### **Correspondence relating to LYT04**

PWP Item No.4119CD  
Drainage Improvement in Northern New Territories - Package CReview of LYT04 as Designated Project

**Agreement No. CE 6/2002 (DS)  
Drainage Improvement in Northern New Territories – Package C  
Investigation, Design & Construction**

**Review of LYT04 as Designated Project**

Figure no. 382486/REV/017C Scale 1:1000

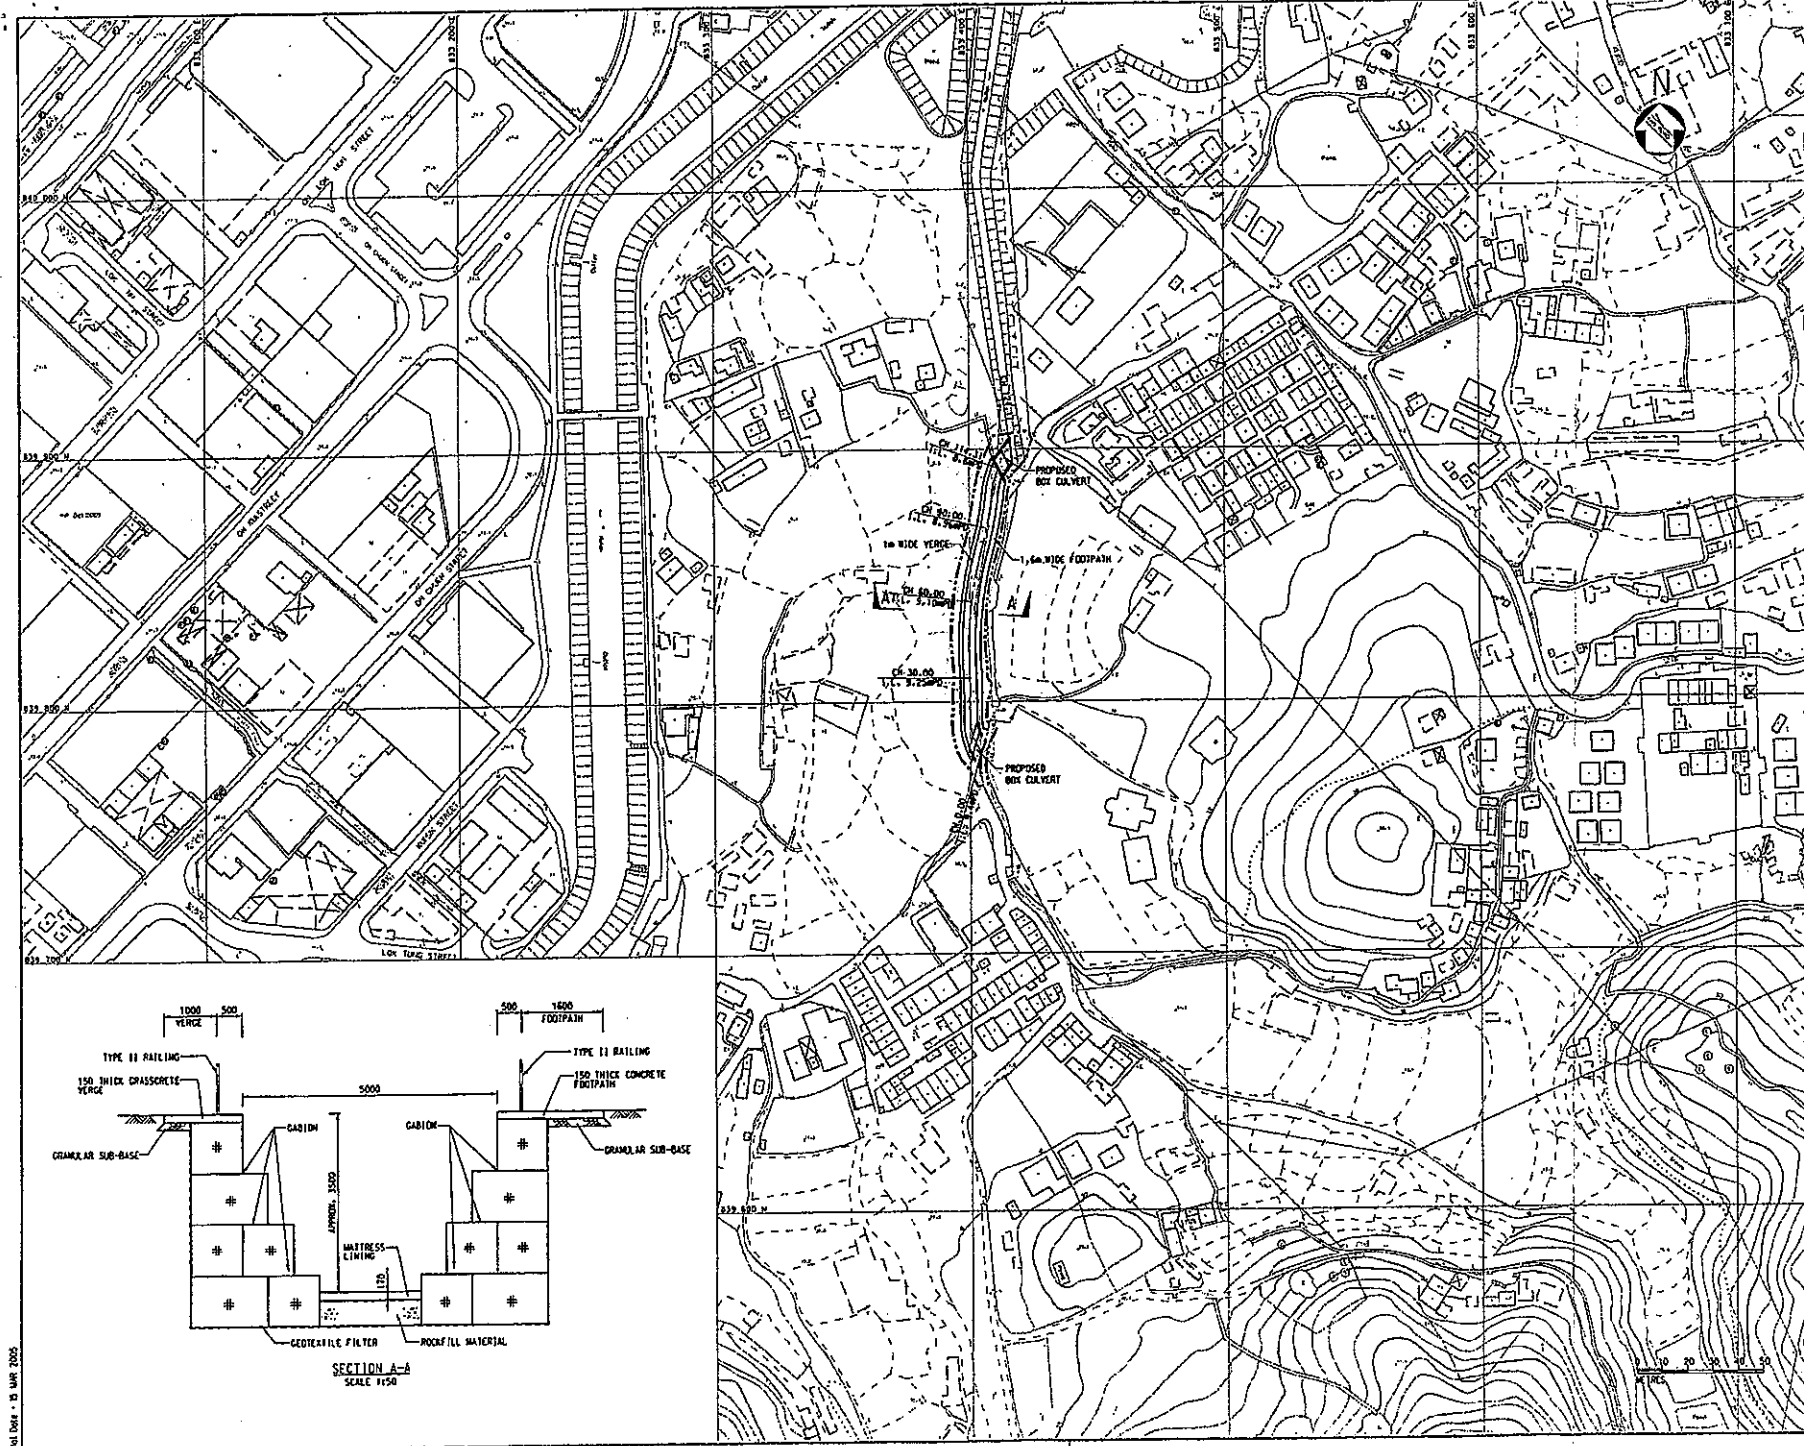
The open channel scheme indicated in the enclosed Figure No. 382486/REV/017C was however objected by village representatives during public consultation and the design was thus reviewed and revised according to the comments received. In the recommended improvement works, the existing single-cell box culvert will be replaced by a new twin-cell box culvert of internal cell size, 2.3m wide by 2.3m high, underneath the existing access road connecting Ma Wat Wai and Shung Him Tong area, as shown in the attached Figure No. 382486/REV/LYT04-1.

LYT04 was classified as a Designated Project due to its open channel design, which clearly falls within the definition of "drainage channel or river training work", at the time of preparing the EIA Study Brief. However, whether the current box culvert scheme still falls within the meaning of the same category is doubtful.

The design has been changed to box culvert underneath the existing access road. Based on the above definition, we consider that the proposed works at LYT04 should NOT fall within the meaning of "drainage channels" or "rivers" under Section I.1 in Part I of Schedule 2 of the EIA Ordinance and should not be regarded as Designated Project. We therefore recommend, subject to agreement of EPD,

- 1) re-defining the proposed works at LYT04 as a non-Designated Project, and
- 2) removing LYT04 from EIA study and incorporating it into the ES Study.
